TOLEDO - LUCAS COUNTY PLAN COMMISSIONS

REF: PUD-10007-20

SUBJECT: Request for an amendment to Planned Unit Development, originally approved by Ord. 87-17, for multi-family development at 801 Division Street.

PLANNED UNIT DEVELOPMENT AMENDMENT OF: COLLINGWOOD GREEN IN THE CITY OF TOLEDO, LUCAS COUNTY, OHIO

SITE PLAN

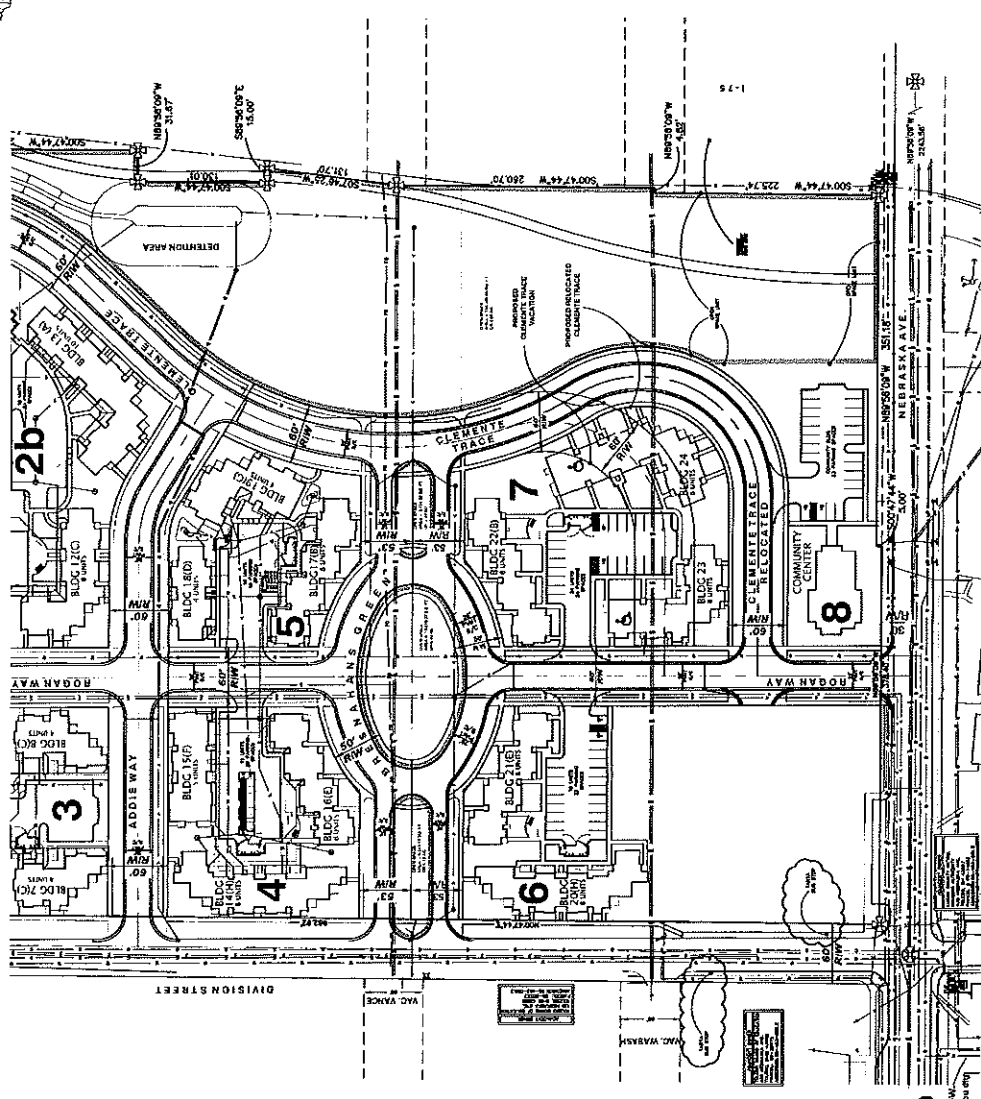
31. Parking shall adhere to the requirements of TMC§1107.0300 – *Parking Schedule “A”*. The parking schedule requires one and a half (1.5) parking spaces per dwelling unit plus one (1) space per ten (10) units for visitor parking. The total number of required parking spaces for 163 units is 261. **Revised site plan received 11/23/20 depicts 223 parking spaces, as well as transit stops. Per TMC§1107.1400(E), the Planning Director may authorize up to a 20% reduction in the number of required off-street parking spaces for developments that provide transit stops. Acceptable as depicted.**

35. Per TMC§1107.0900, twenty-two (22) bicycle parking spaces are required. **Not acceptable as depicted on site plan. A revised site plan with bicycle parking shall be submitted.**

LANDSCAPE PLAN

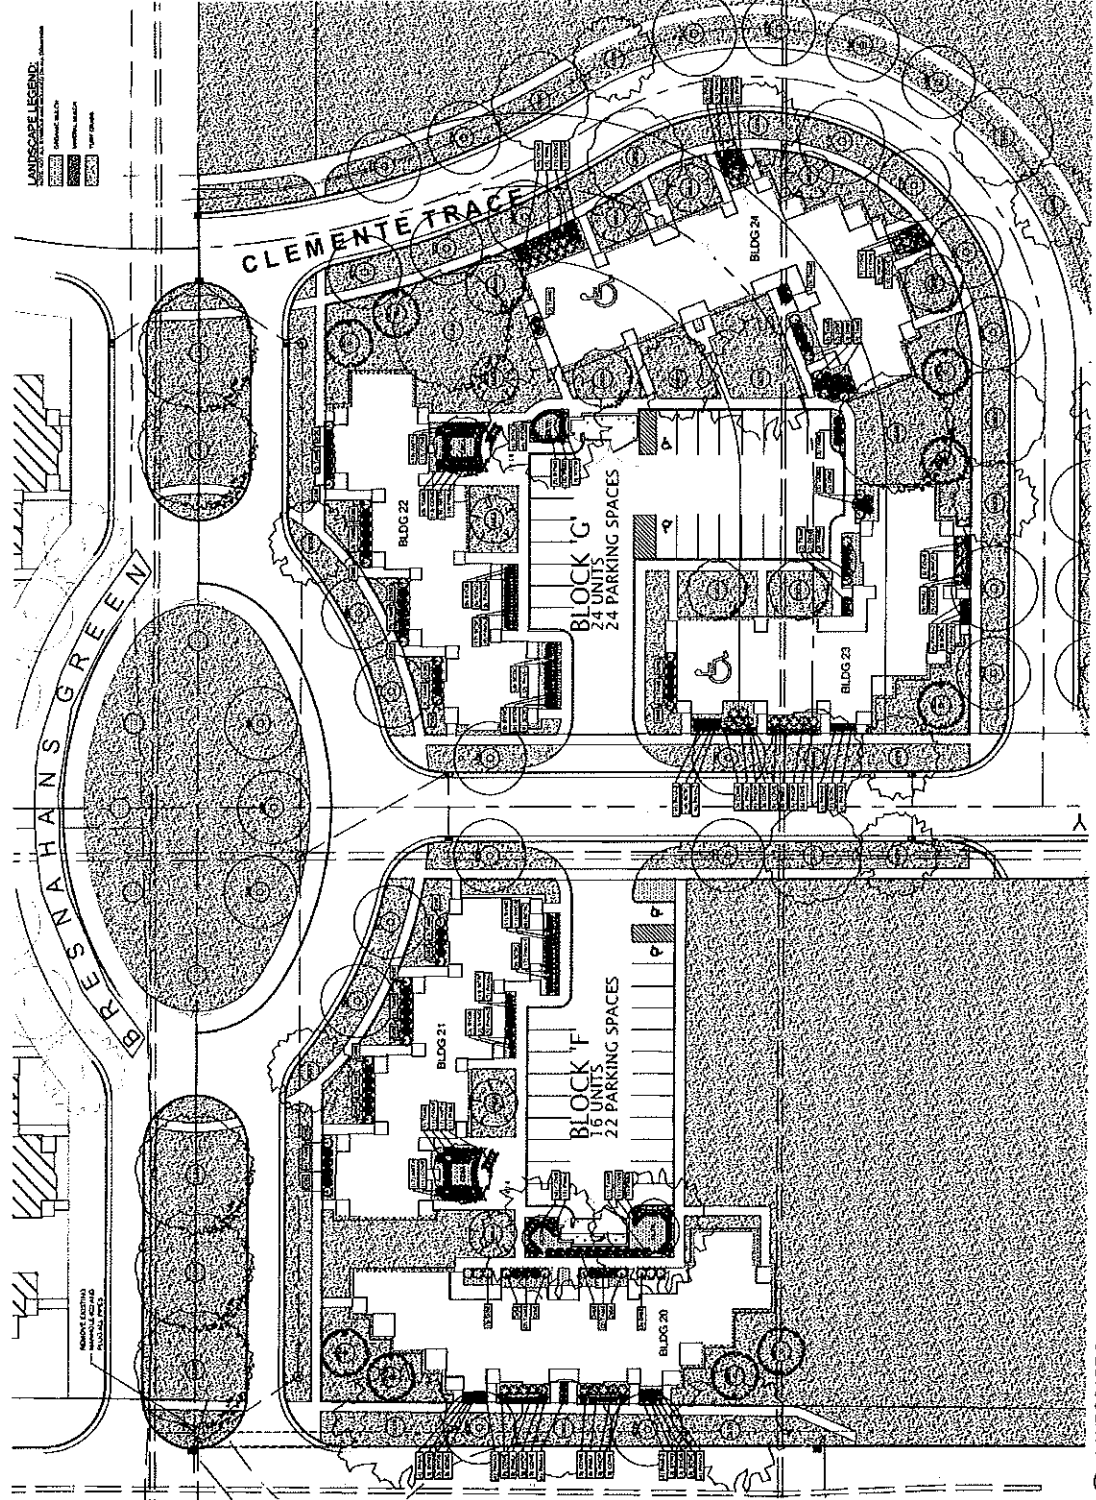
- a. A fifteen-foot (15') greenbelt is required along all proposed frontage, and shall include one (1) tree per every thirty feet (30') of frontage; **not acceptable as depicted, seven (7) additional trees are required along Nebraska Avenue,**

- b. Per TMC§1108.0203, A Type A landscape buffer shall be provided where Residential Zoning Districts abut Commercial Zoning, **noted for future development of the parcel zoned CN Neighborhood Commercial,**

- c. Perimeter landscaping shall be installed along any parking lot area adjacent to a street, place, or driveway and shall be provided abutting the parking area to visually screen all off-street loading facilities from view of public right-of-ways. A minimum of at least one canopy tree must be provided for each 30 linear feet, plus a continuous shrub with a minimum height of 18 inches; **acceptable as depicted,**

- d. Interior landscaping required in parking lots is 20 sqft per parking and stacking space. Two (2) canopy trees are required to be installed in interior landscape areas for each ten (10) parking spaces within the parking lot. Six (6) shrubs are required to be installed in interior landscape areas of each ten (10) parking spaces within the parking lot. One canopy tree may substitute for three (3) shrubs. Trees do not need to be equally spaced; **acceptable as depicted,**

- f. Per TMC§1108.0205, in addition to the other landscape requirements for buffer areas, frontage greenbelt, and landscaping for parking lot areas, the following shall be provided: one (1) tree per 500 square feet of building coverage, or fraction thereof, for all structures. Greenbelt frontage trees are included in this total, minimum of two (2) trees in the front and side yards. Foundation plantings for the full street-facing building elevation; and landscape areas at major building entrances, **acceptable as depicted**,

- g. Dumpster location(s) shall be clearly defined, have a concrete pad and be surrounded by a solid wooden fence or a masonry screen enclosure with landscaping and shall not be located in any required setback, **acceptable as depicted**,
